Section 96 Modification to Development Consent – SSD 5300 Kembla Grange Resource Recovery Facility Upgrade

The proposed modification to consent SSD5300 involves the installation of a larger demountable weighbridge office to service the new inbound weighbridge and the existing outbound weighbridge, and a slight realignment of the new weighbridge to be in line with the existing weighbridge. In the original design, a small weighbridge management office was to be installed adjacent to the new weighbridge, which would only service inbound vehicles. The proposed development will improve vehicle movement efficiency by ensuring that all weighbridge management occurs within a single office between the weighbridges.

DRAINS Model
100yr ARI with new Weighbridge Office

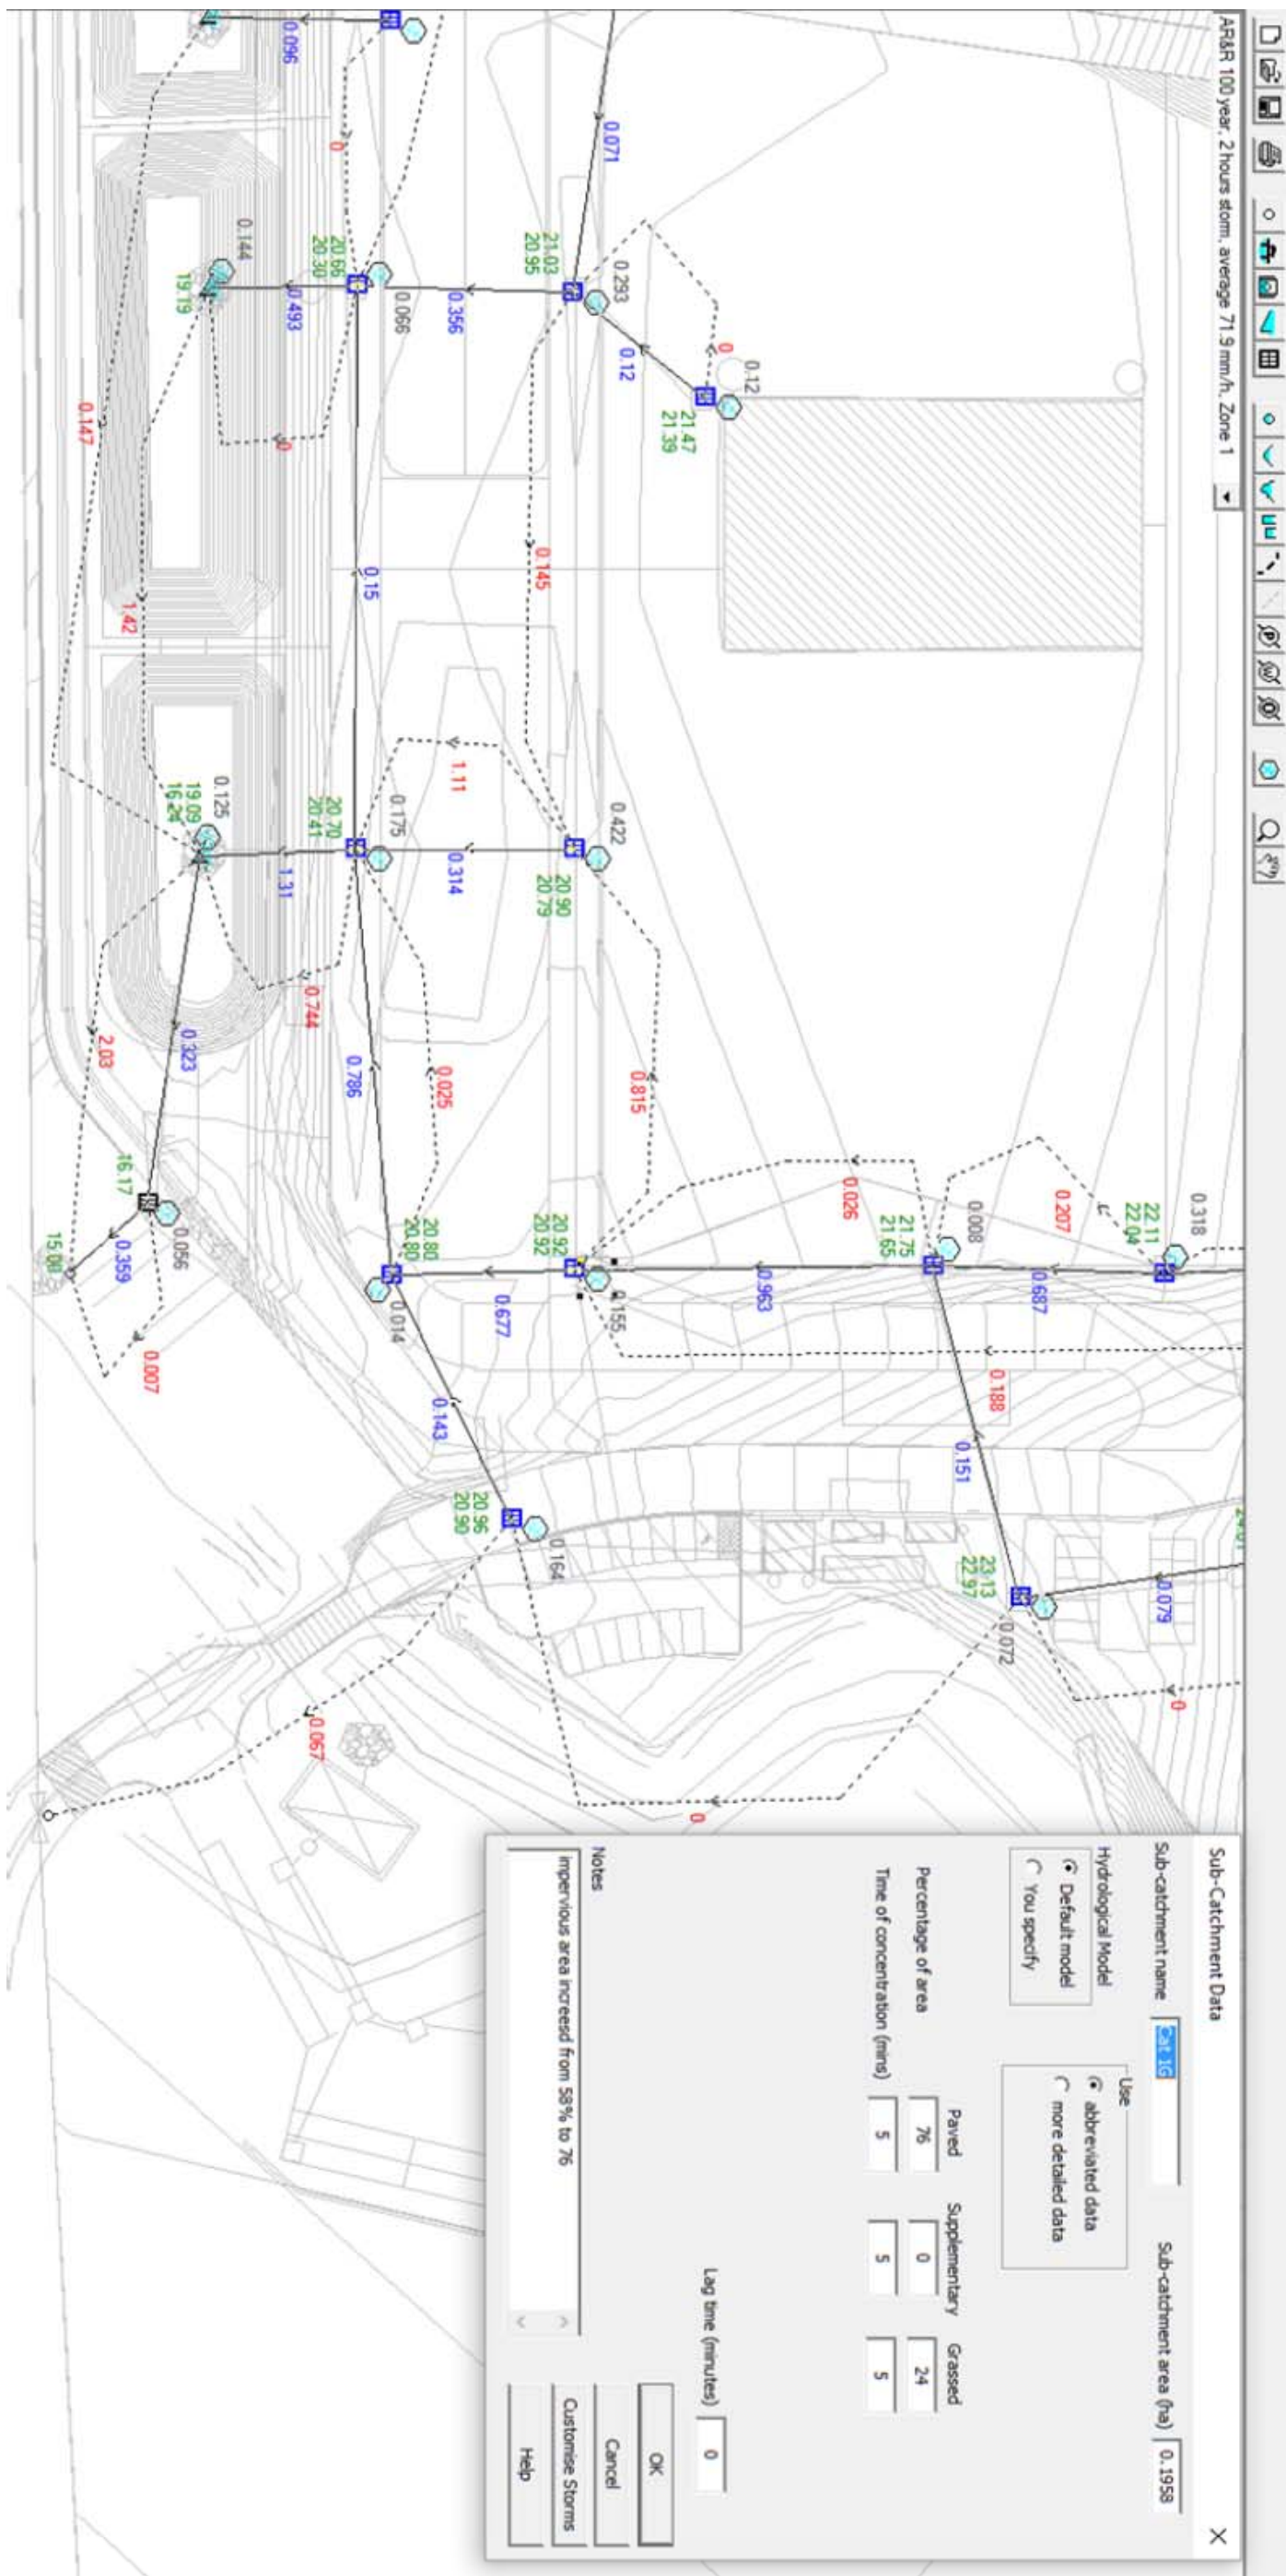
An update to the stormwater model DRAINS to include the increase in impervious areas found:

- No increase in discharge from the detention basin. Site discharge remains at 0.359 m³/s with 0.007 m³/s weir flow for a 100 year ARI storm burst. The additional 0.003 m³/s (Pit 1G) from the weighbridge office area to the detention basin has no effect on site discharge; and
- The proposed larger weighbridge office and associated site works will not increase the peak runoff from the site.

The stormwater model DRAINS was modified to include the additional impervious area draining to pit 1G.

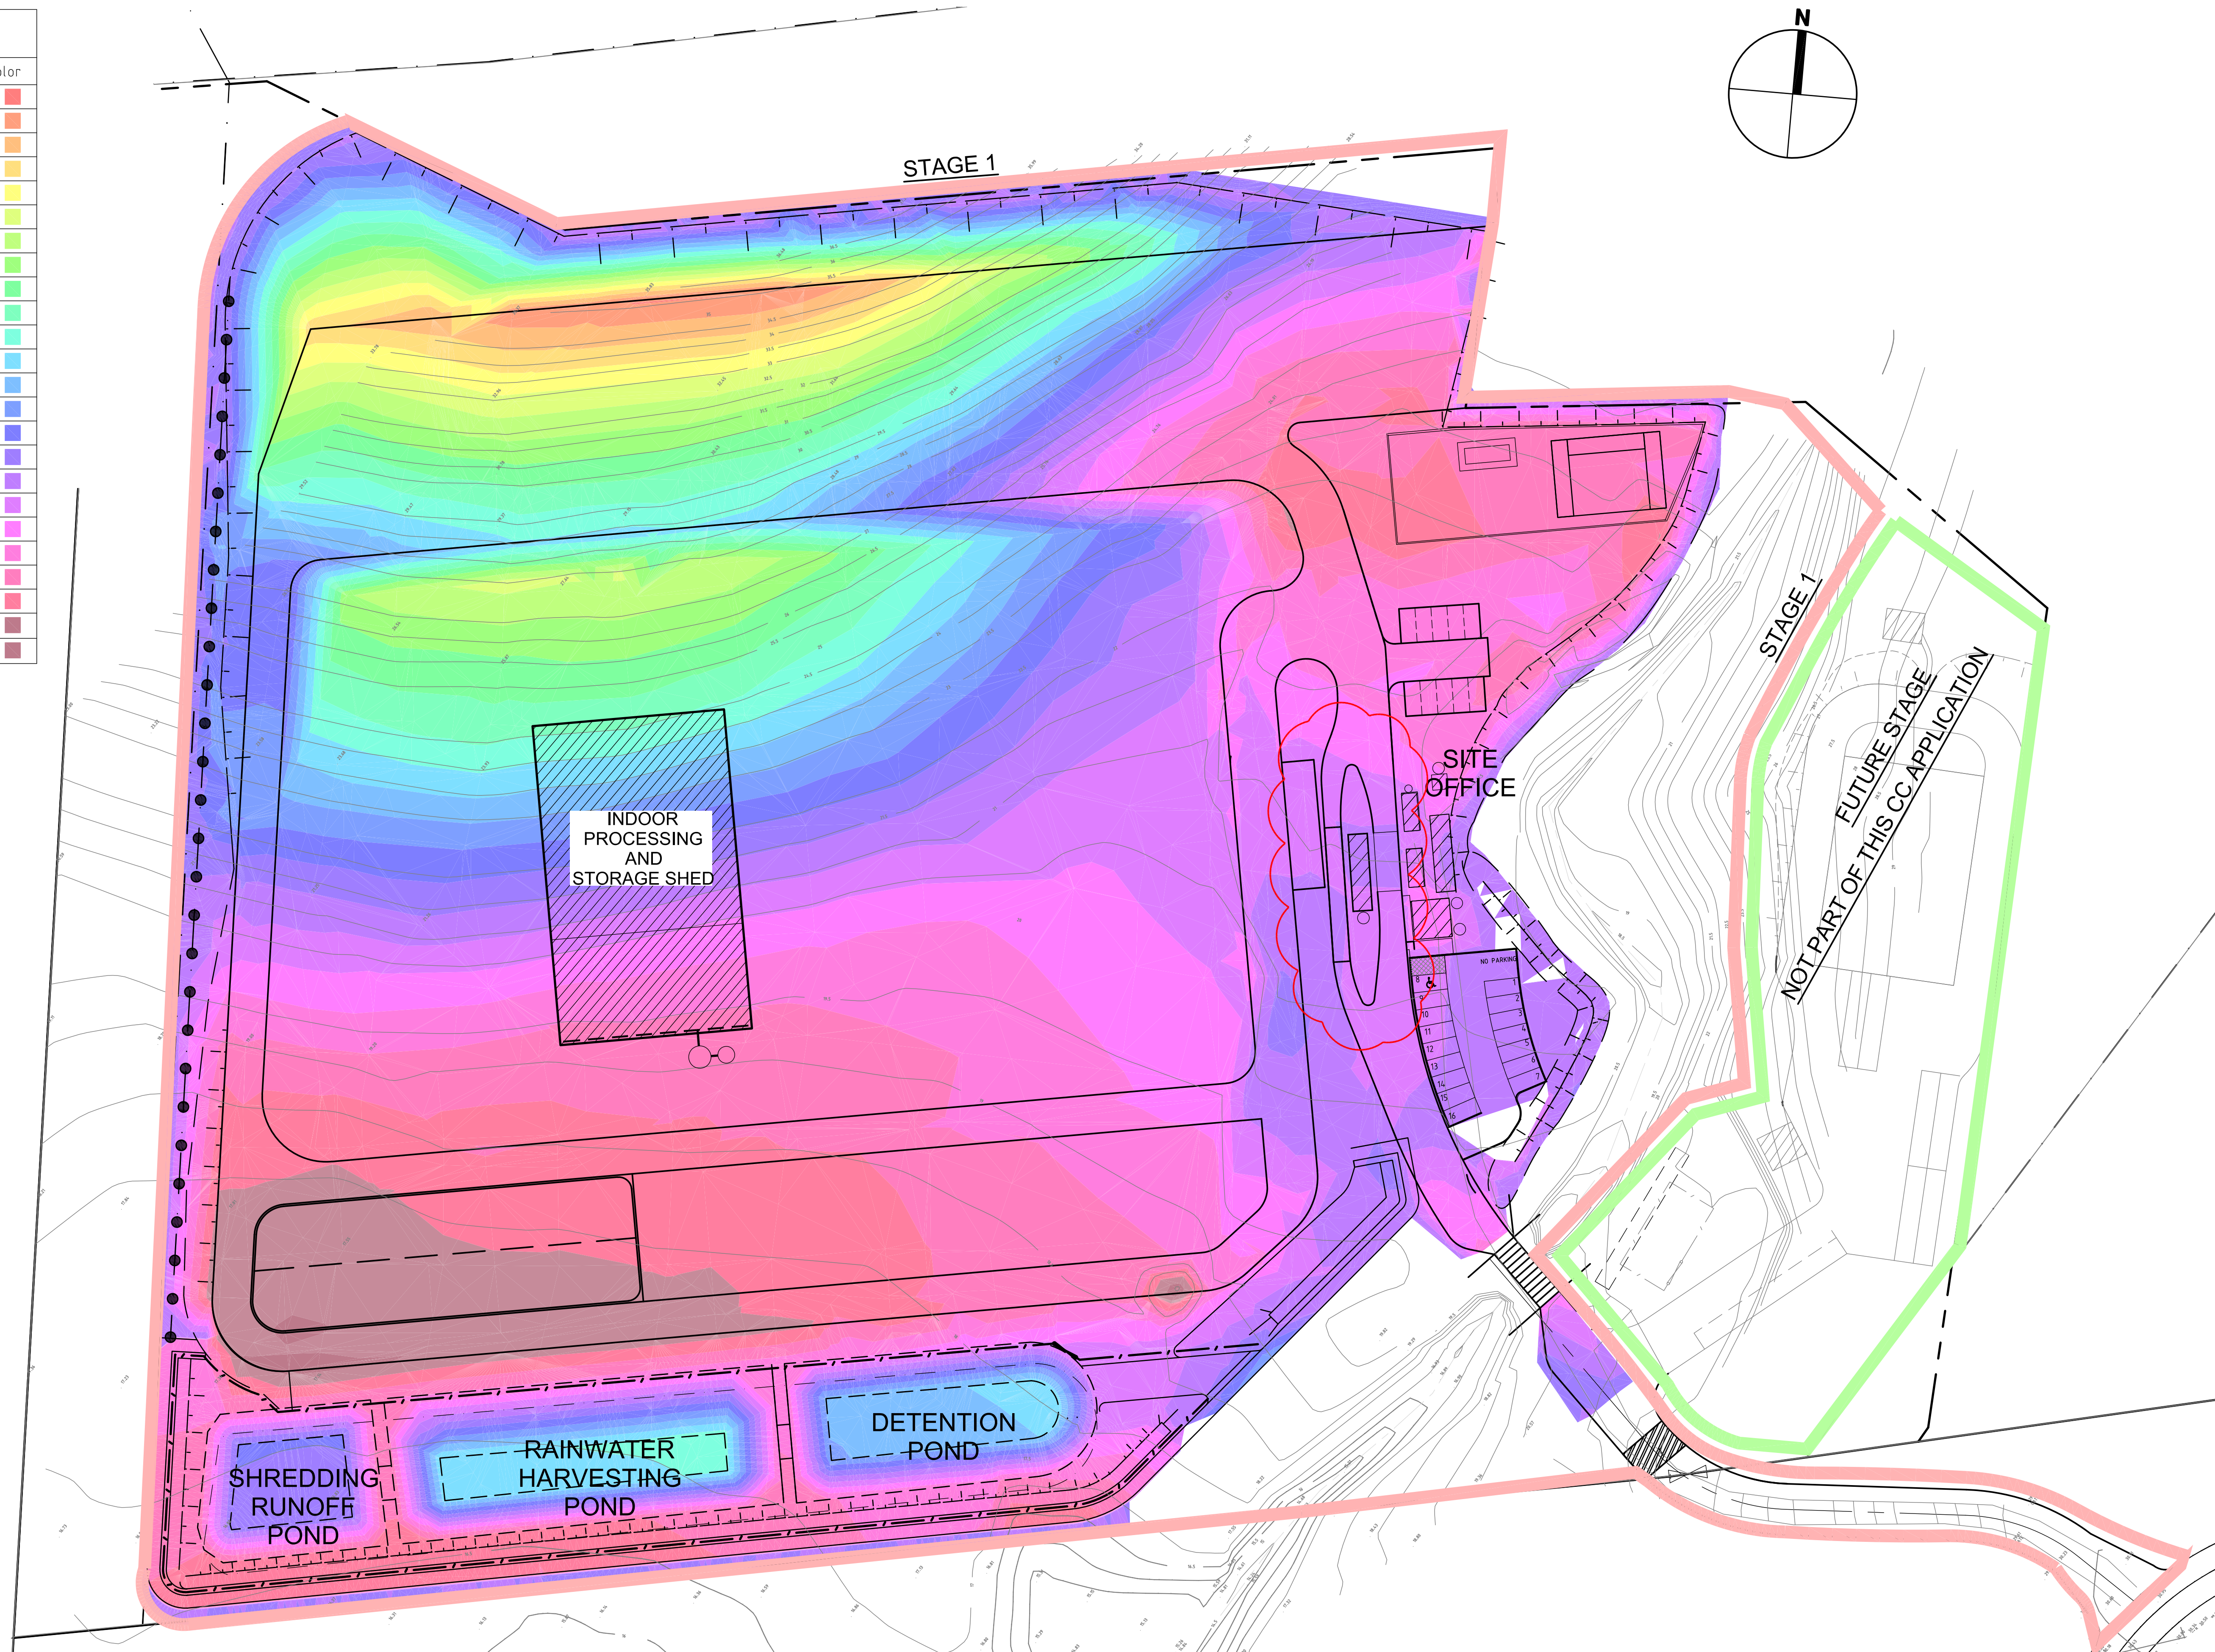
A	WEIGHBRIDGE LOCATION AMENDED	24.01.2017	B.M	W.M
Revision	Amendment or reason for issue	Issue date	Drawn by	Authorised

DESIGN VEHICLE:
ARTICULATED HEAVY VEHICLE

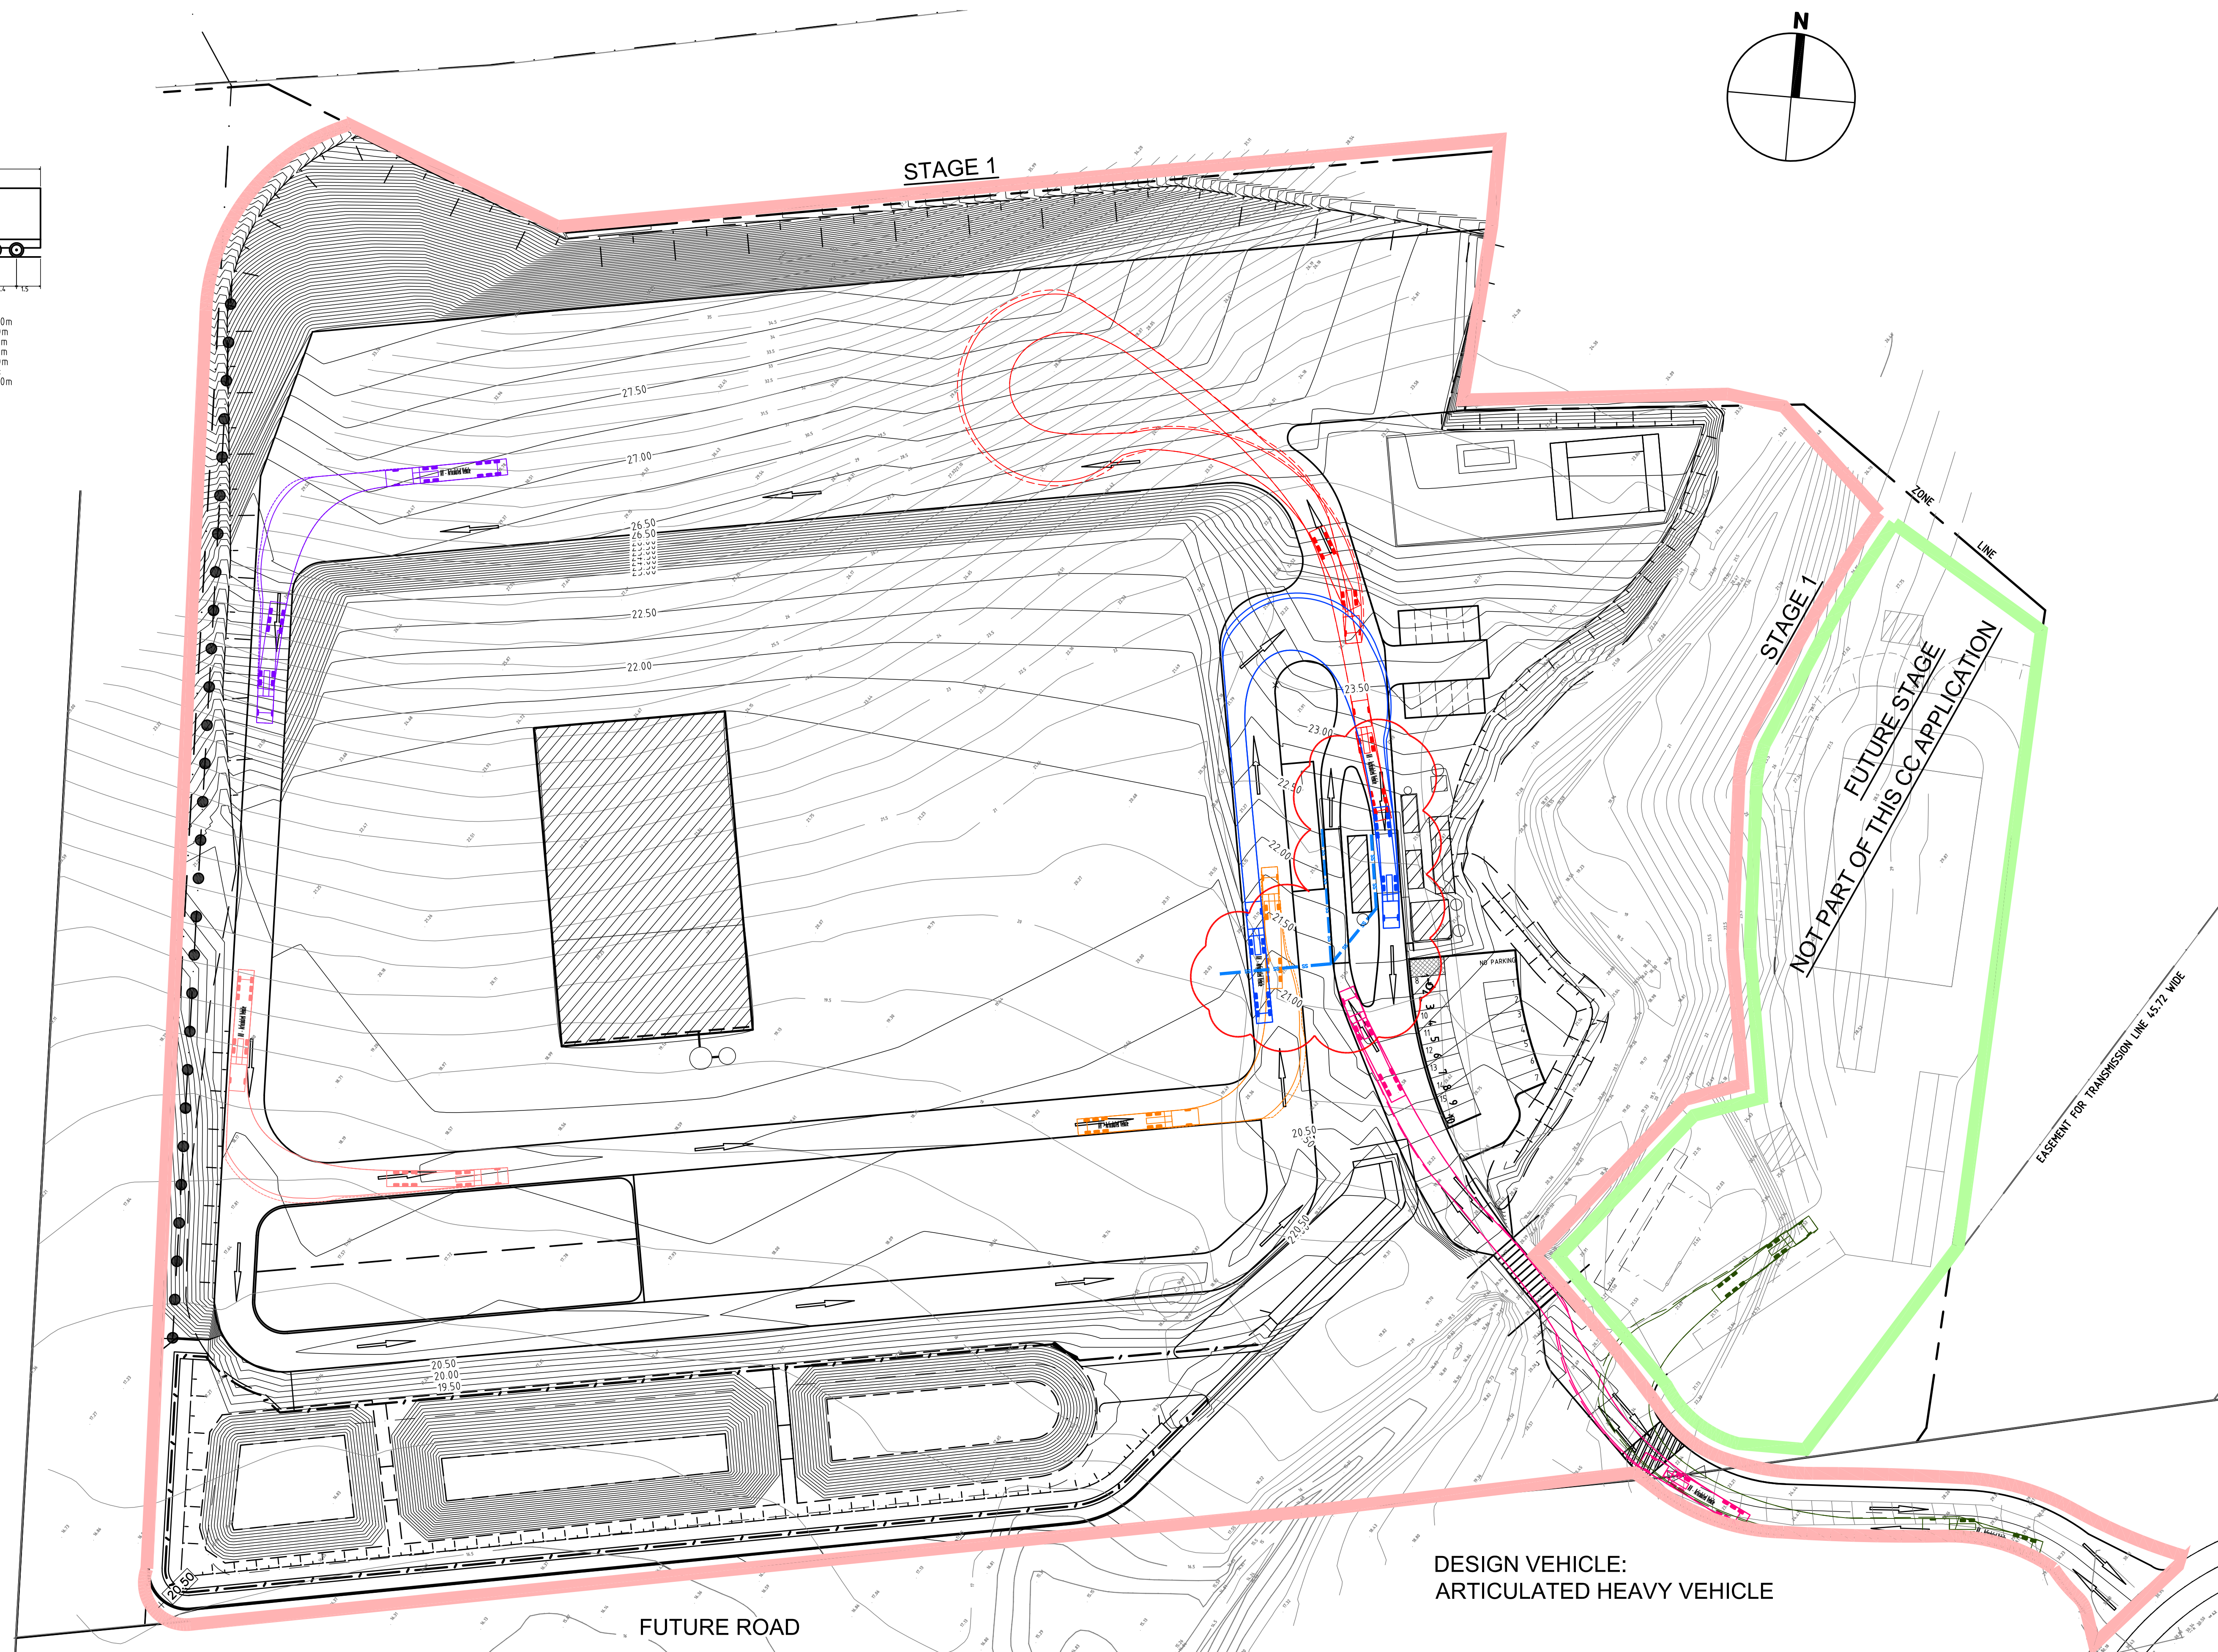
An analysis of the impacts of the minor widening of the inbound and outbound carriageway associated with the approaches to the weighbridges has been performed to assess any impacts on vehicle turning paths on the site. An update to Plan C305 as approved at the Construction Certificate Approval stage has been done. This is given in Appendix 5, together with an update to all remaining plans finalised for the Construction Certificate approval.

An assessment of vehicle turning paths for the minor widening of the inbound and outbound carriageway for the largest articulated heavy vehicle to enter the site (articulated vehicle length of 19.5m) suggested that the modification to the design will have no impact on the ability of vehicles to safely enter, manoeuvre and exit the site.
